FINAL ENVIRONMENTAL IMPACT STATEMENT

EAST PARCEL REDEVELOPMENT

Sleepy Hollow, New York

March 2017

Exhibit II-22
Conceptual Design Treatments
Proposed Continental Street Overpass
East Parcel Redevelopment FEIS

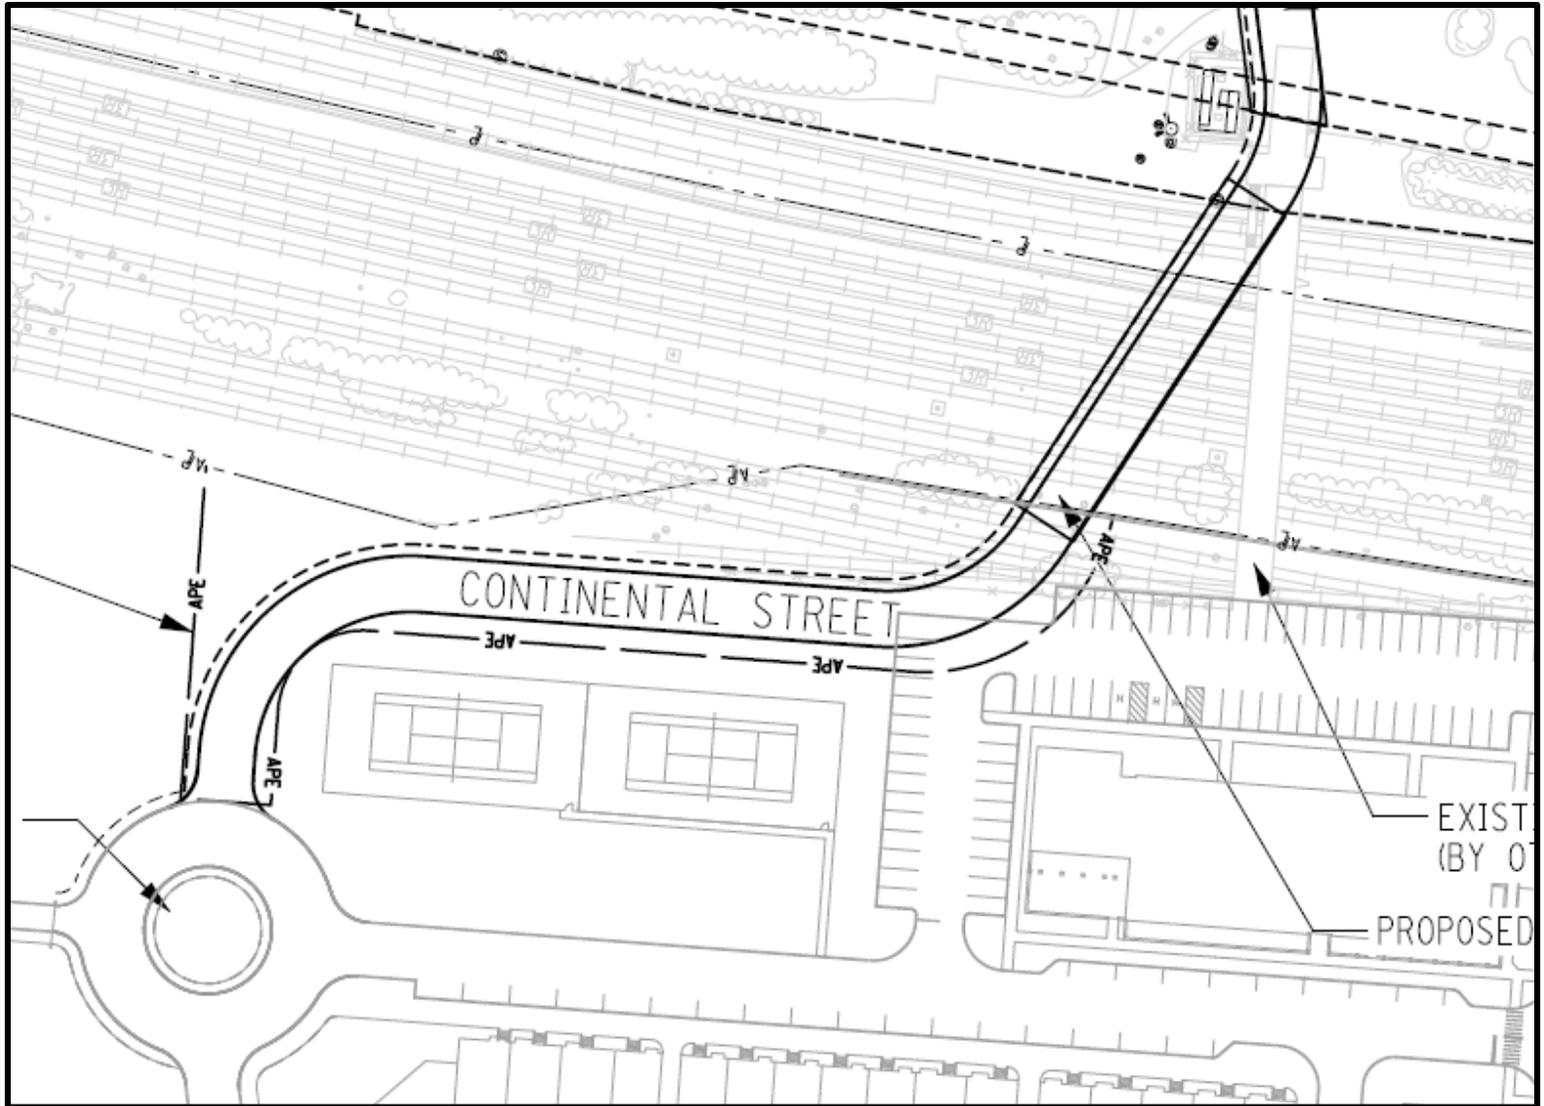
Continental Street Overpass – DEIS Section III.B.2 describes anticipated impacts and proposed mitigation associated with the proposed Continental Street Overpass (Overpass) when viewed from the east but not from the west. The Overpass structure is shown to be located approximately 60 feet from the northeast corner of EOH Building I-1, which will house 40 senior affordable rental units. Please provide information on the design of the structure, including anticipated spot elevations and proposed architectural, lighting and landscape architectural treatments.

The roadway grade up to the elevated spans will be accomplished via fill ramps on both the east and west parcel supported by a mechanically stabilized wall system. The wall panels will be designed considering the use of form liners to compliment the aesthetics of the site. Exact color and texture of the wall panels will be determined at future phases of design, representative examples of wall panels are provided as FEIS Exhibit II-22a and b. Other aesthetic elements including bridge railing and lighting will be determined as part of specific site plan review and approval.

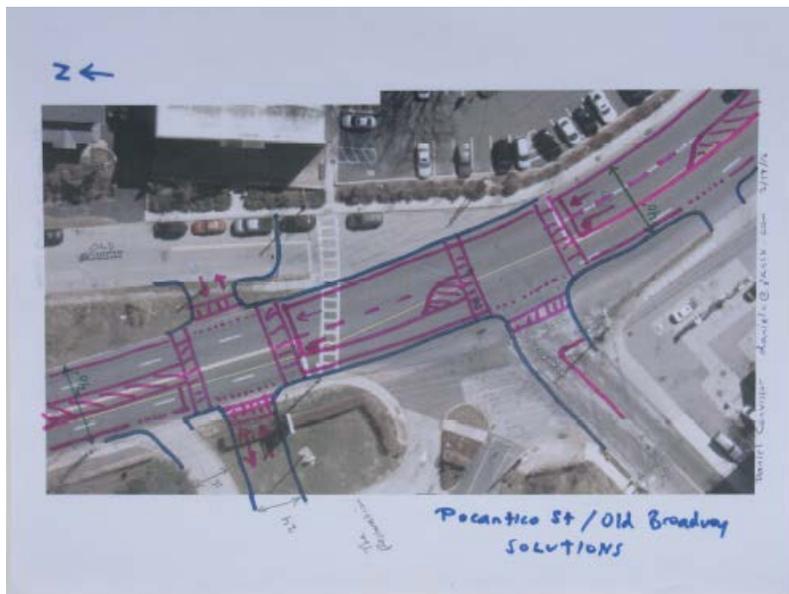
Abigail Jones, Letter 33, September 30, 2016
